REFERENCE:	Nova Bus Manuals
SECTION:	10: Transmission and Control
RS N°:	MQR 7621-2486
EFFECTIVE IN PROD.:	N/A

SUBJECT:	Transmission Coolant Pipes
JUSTIFICATION:	P-clamps holding the transmission coolant pipes can break and cause coolant leaks.

Figure 2 - The two P-clamps Securing the two Transmission Coolant Pipes

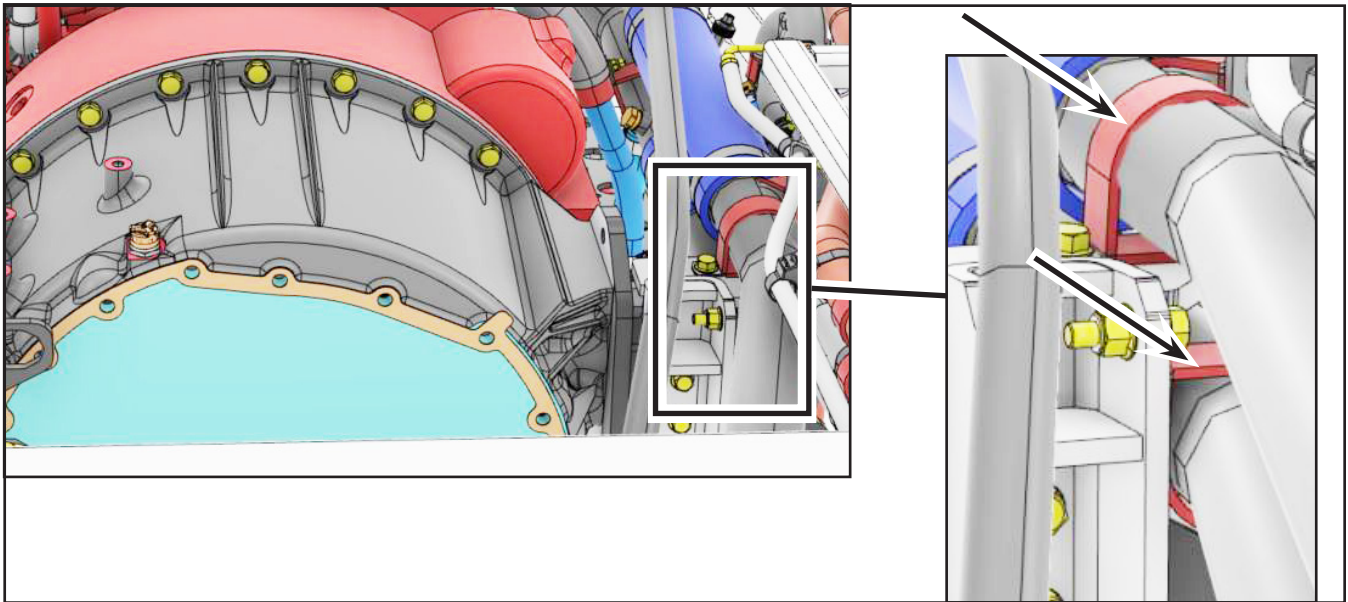
- 1.5. Locate the two P-Clamps mounted on the engine cradle bracket that secure the two coolant pipes (Figure 2).
- 1.6. Remove the two P-clamps, the screws and the nuts. Discard the P-clamps (Figure 3).
- 1.7. Prior to their installation, it is recommended to pre-bend/preform the 2 new P-clamps N31320-09 to facilitate their installation.
- 1.8. Install the two new P-clamps with the removed screws and nuts. Torque to the torque value of 17 ± 2 lb-ft (23 ± 2 N•m).
- 1.9. Close the transmission access trap.

LEVEL	DESCRIPTION	DIRECT CHARGES		TIME
		LABOUR	MATERIAL	
1	Replace two installed P-clamps with two thicker ones.	Nova Bus	Nova Bus	45 min
2	–	–	–	–

QTY	PART N°	REV.	DESCRIPTION
LEVEL 1			
2	N31320-09	–	CLAMP LOOP TYPE ID 2" .063" THK
LEVEL 2			
–	–	–	–
